CITY OF ALBUQUERQUE

**RE: Lot 5 Block 8, Unit 22 Volcano Cliffs
6412 Canavio Pl NW
Grading and Drainage Plan
Engineers Stamp Date 3/25/15 (D10D00E5)**

GRADING & DRAINAGE PLAN

LOTS 5-6, BLOCK 8, UNIT 22 VCS

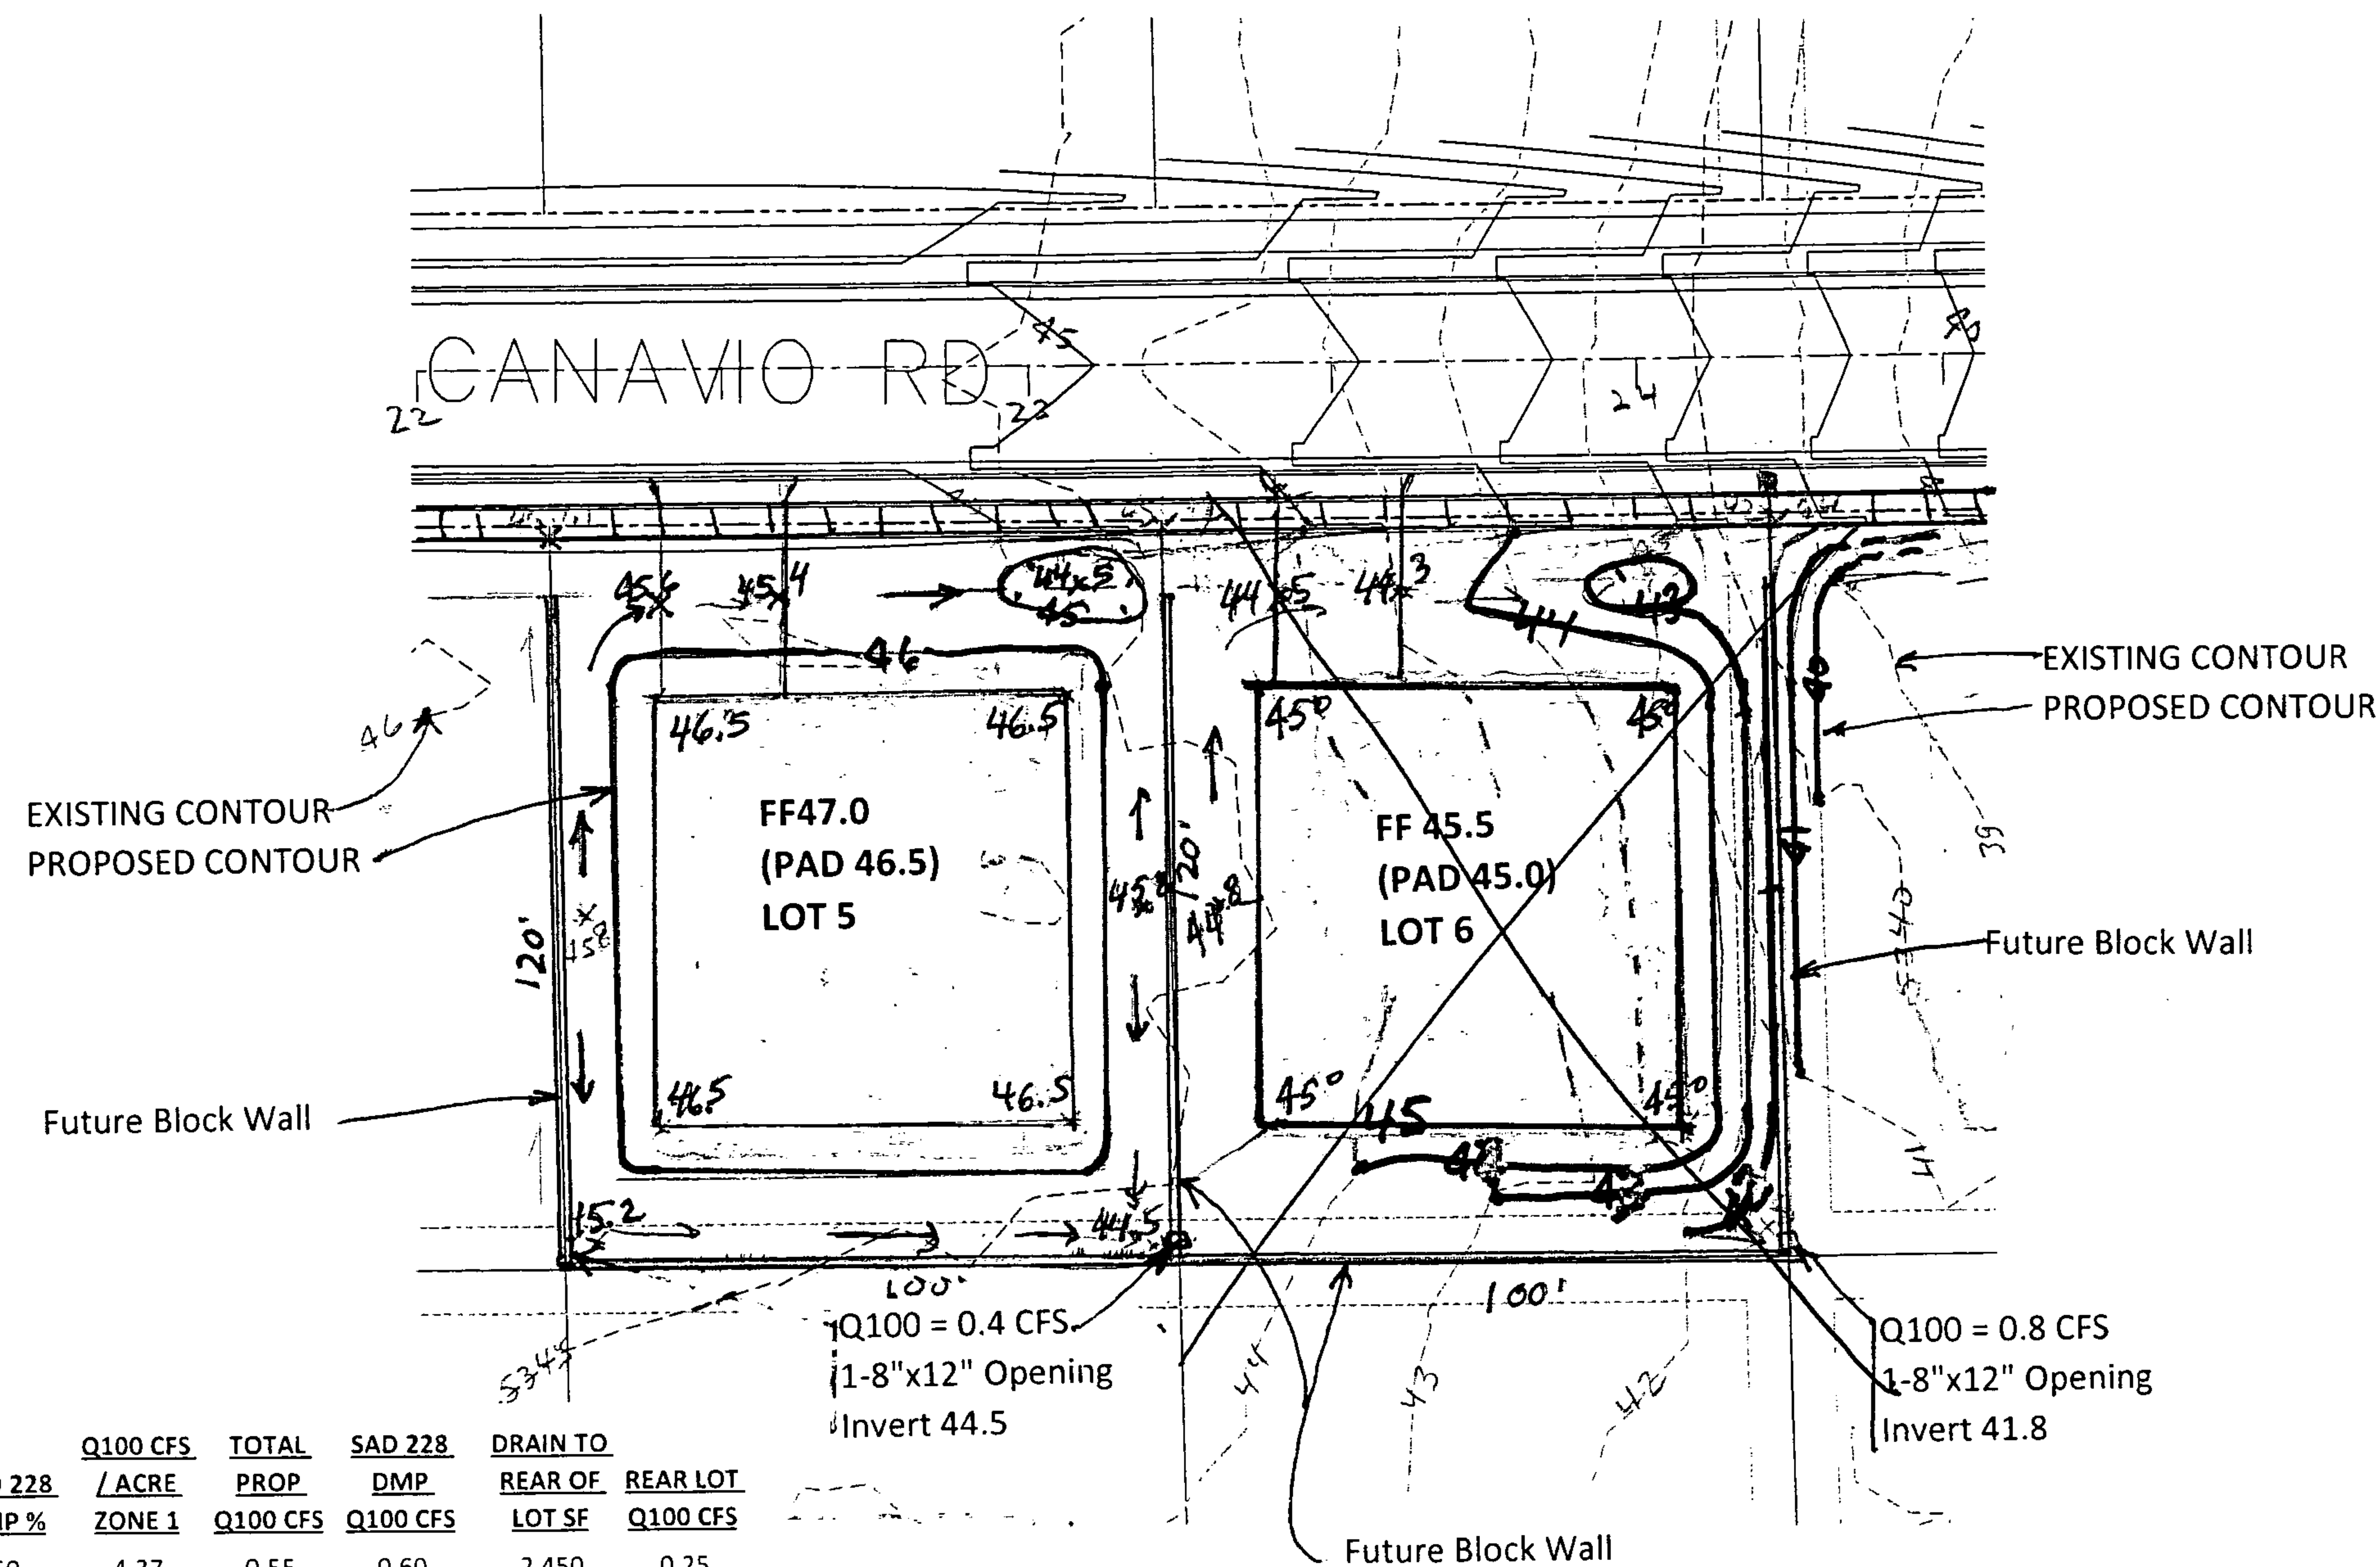
Based upon the information provided in your submittal received 3/25/2015, this plan is approved for Grading Permit and Building Permit.

Please attach a copy of this approved plan to the construction sets in the permitting process prior to sign-off by Hydrology.

Prior to Certificate of Occupancy release, Engineer Certification per the DPM checklist will be required.
